No.	REVISION	BY	DATE	H-SCALE 1"=300'	V-SCALE N/A	DATE 1/23/23	DESIGNED BY DJV	DRAWN BY WUL	CHECKED BY	SAND CREEK RESTORATION	GEC PLANS	SHEET 90 OF 111	JOB NO. 25188.04

SAND CREEK RESTORATION

GEC INITIAL

UNTIL SUCH TIME AS THESE DRAWINGS ARE APPROVED BY THE APPROPRIATE REVIEWING AGENCIES, OR ENGINEERING AGENCIES, THEIR USE APPROVES THEIR USES DESIGNATED BY WRITTEN AUTHORIZATION.

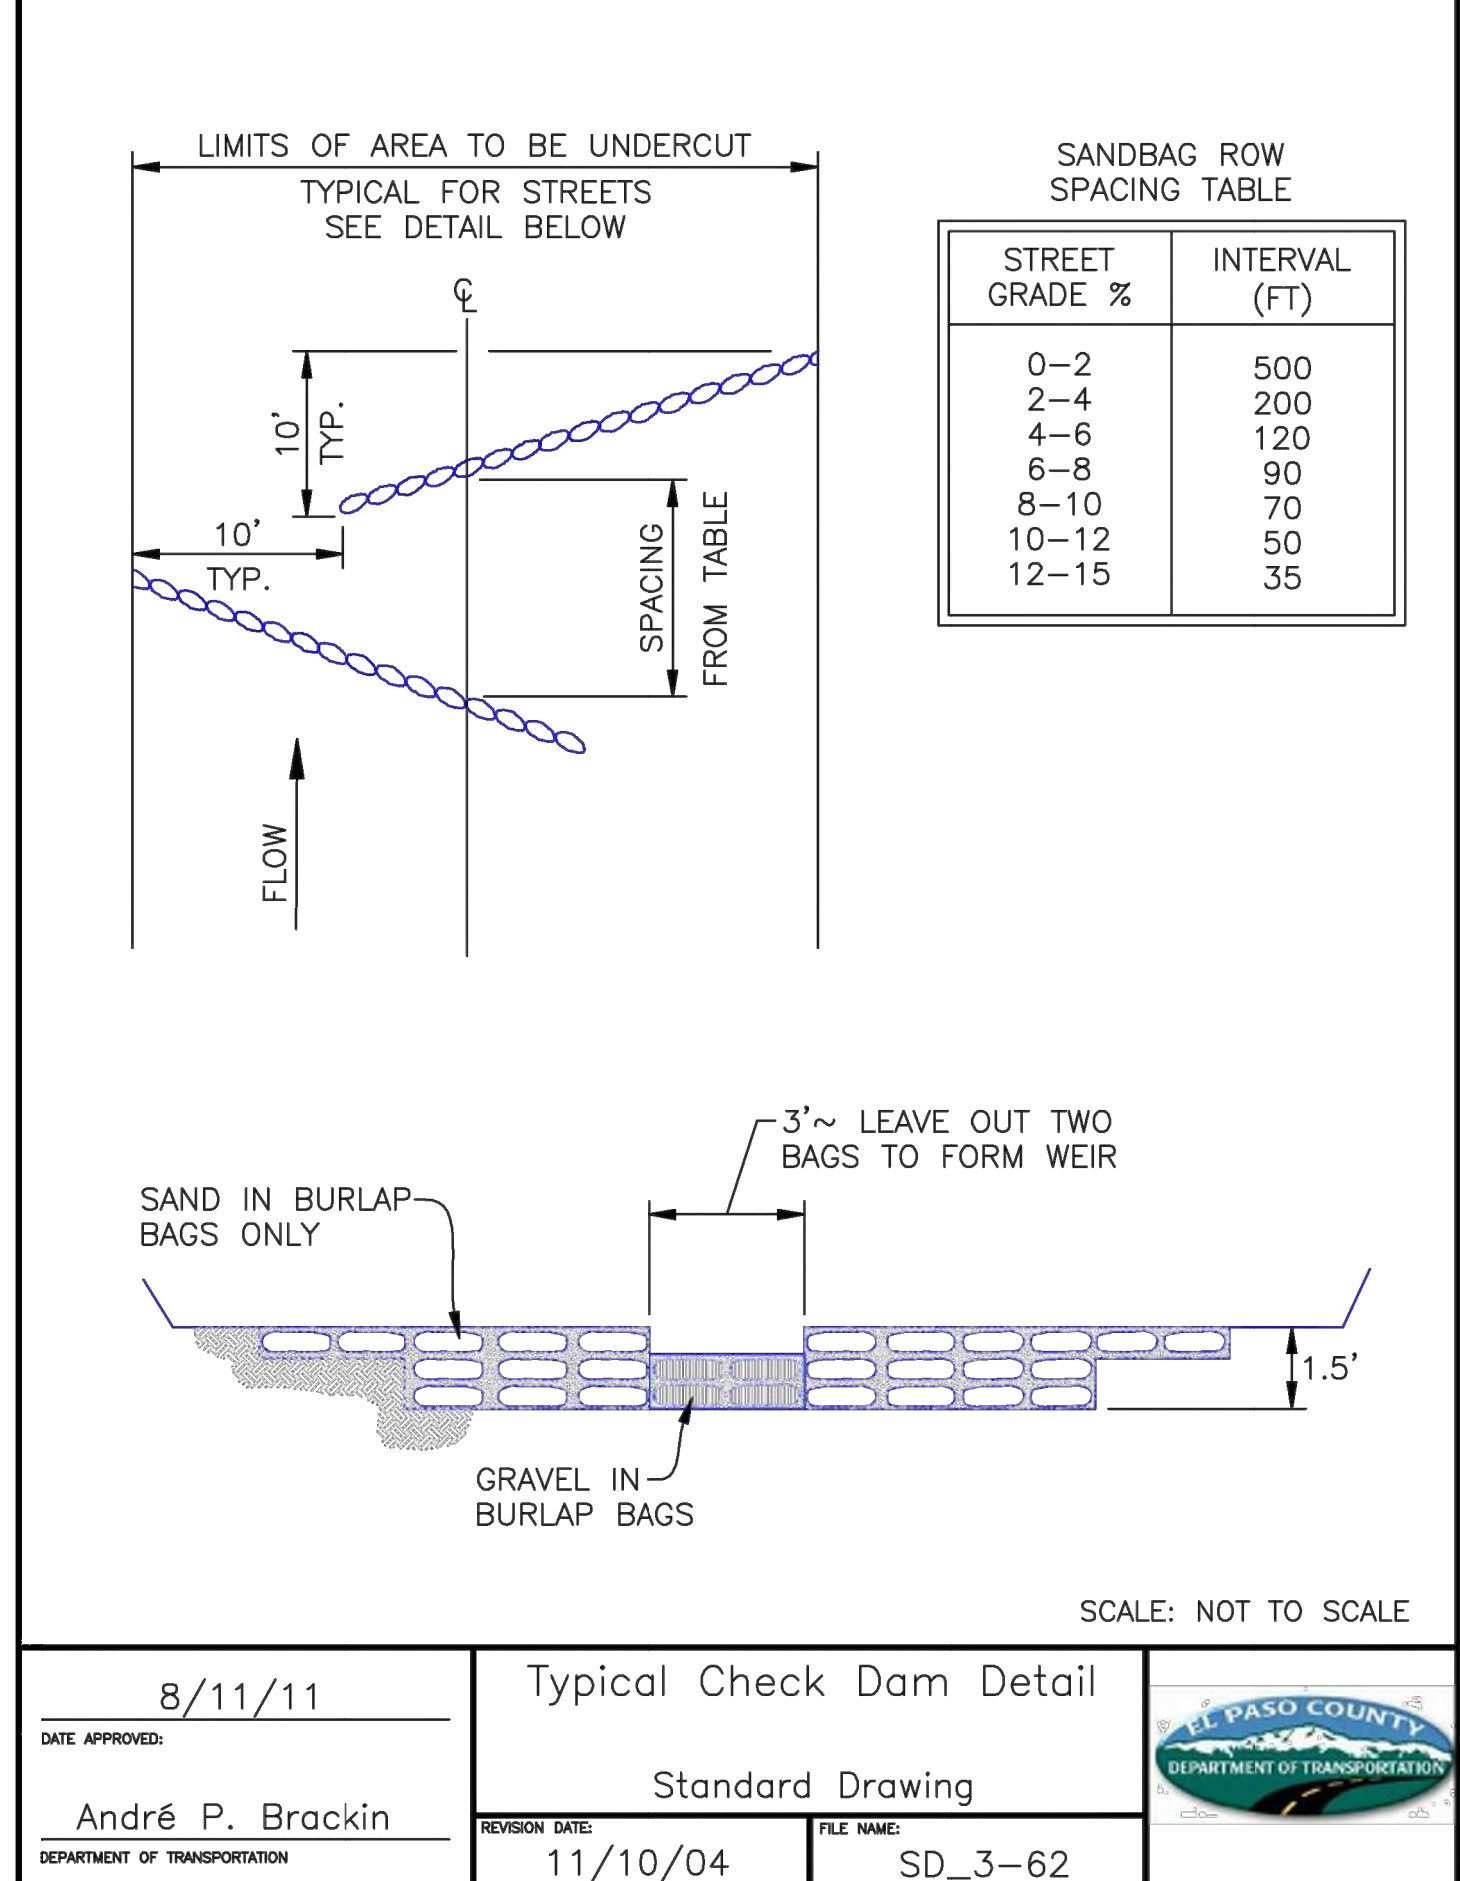
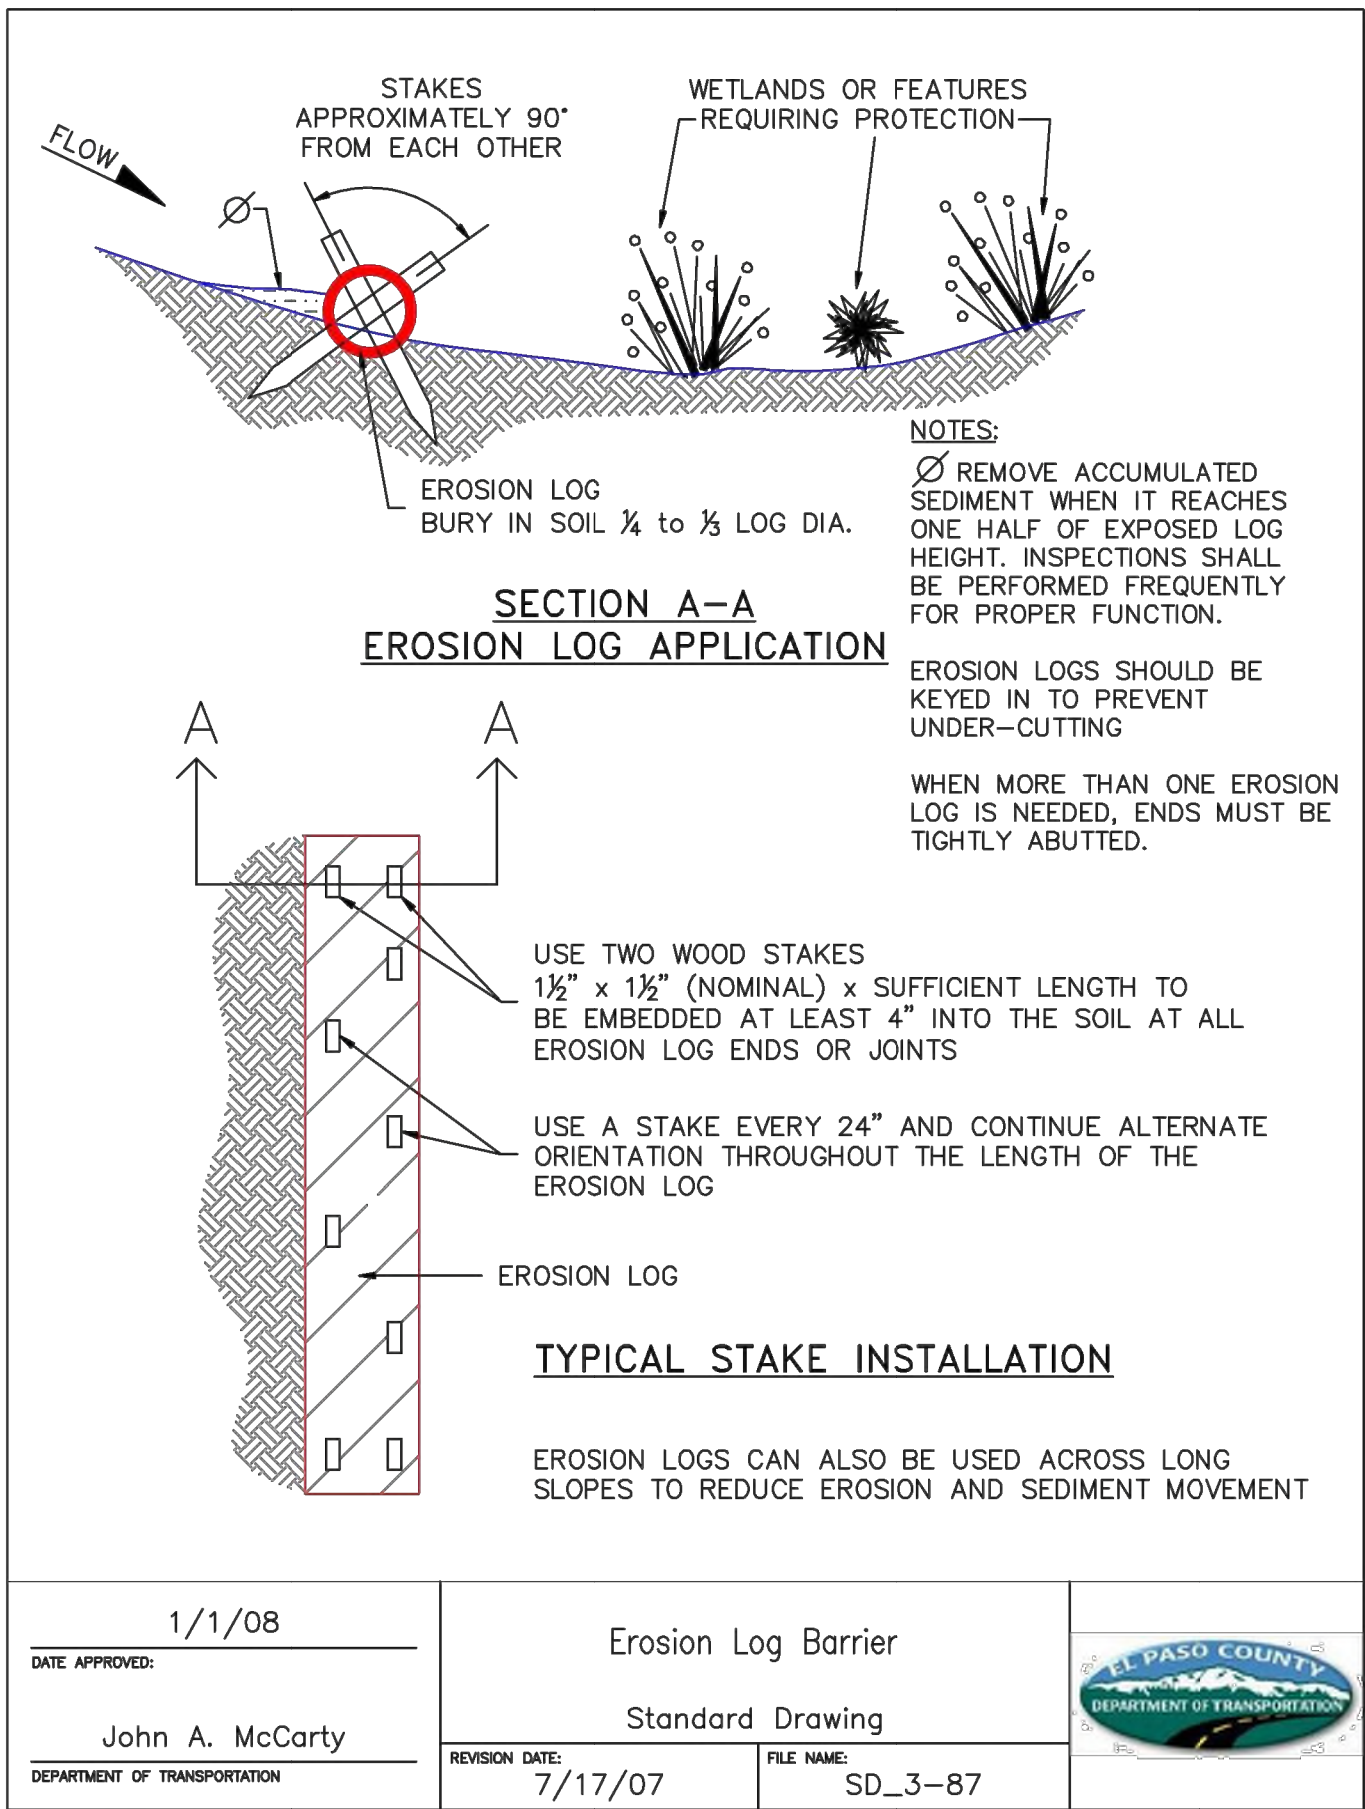
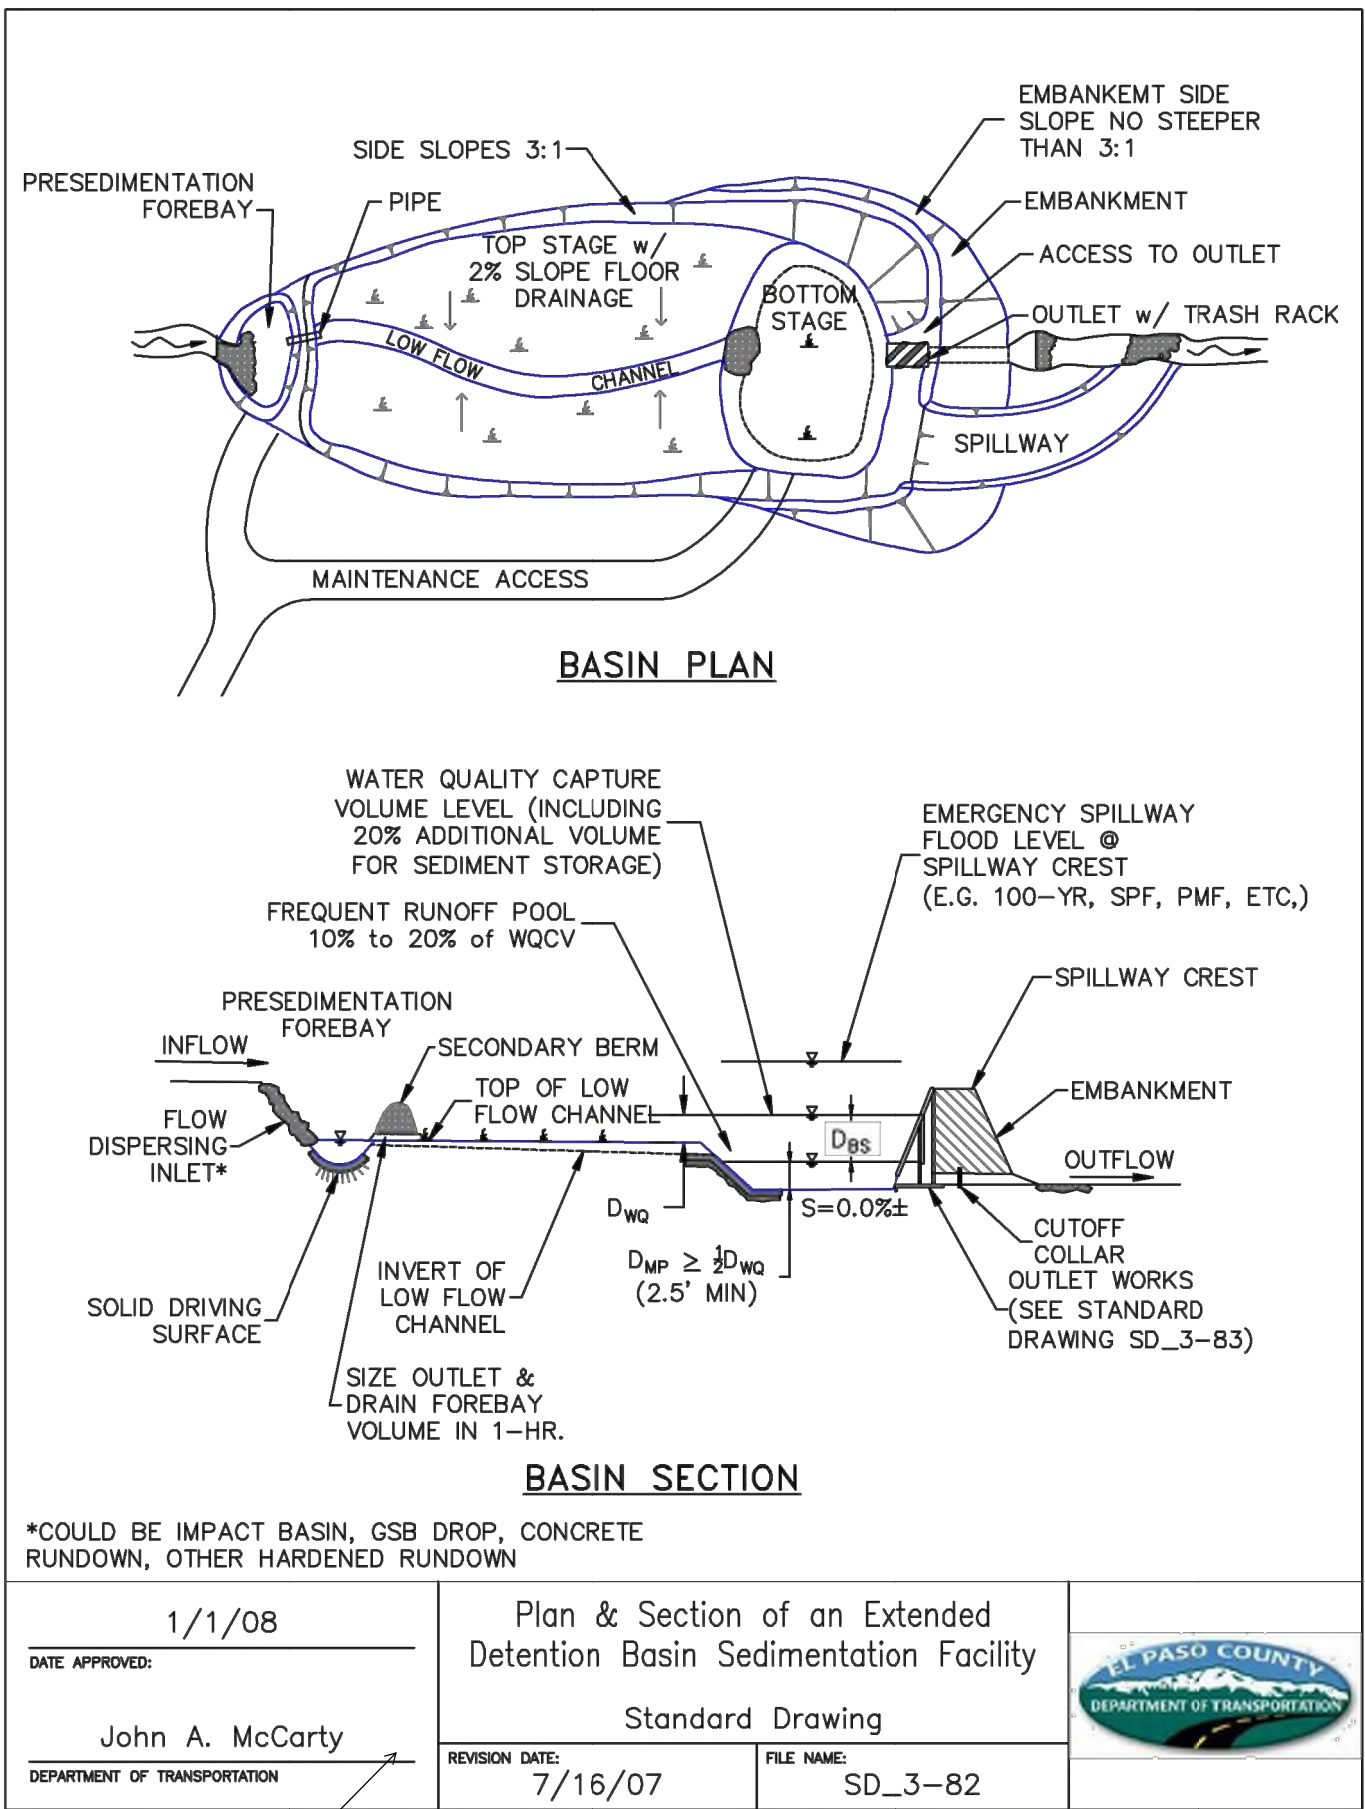
Provide channel check dam detail
